## Product Change Notice (PCN)

**Subject:** Change Leadframe Supplier  
**Publication Date:** 12/23/2022  
**Effective Date:** 1/22/2023

**Appendix A - Qualification Results**
**Affected Packages:** VFQFPN-100

POD Current Leadframe Supplier  
(CWTC, Japan)

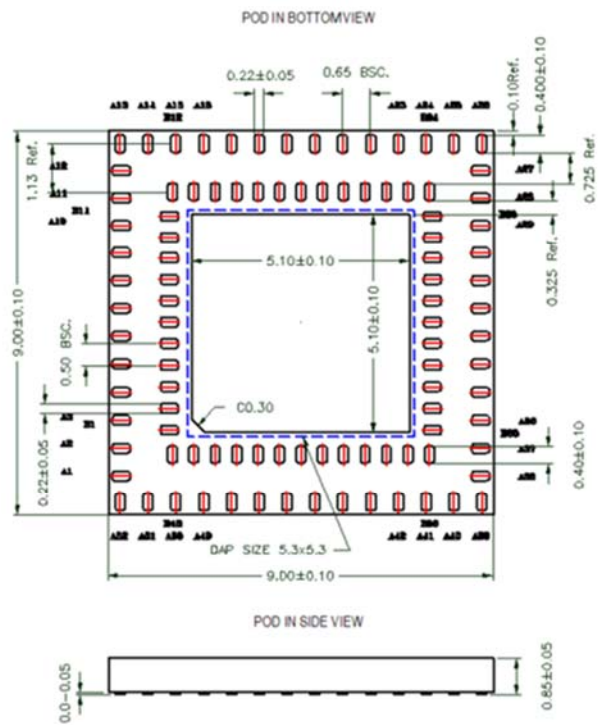
This notification is to advise our customers that Renesas is changing leadframe supplier from CWTC, Japan to Rokko, Malaysia due to the current supplier has ceased the operation. There will be no change to the leadframe base material, Eftec-64T as well as the package outline drawing since the new supplier follows exactly the existing supplier's leadframe drawing.
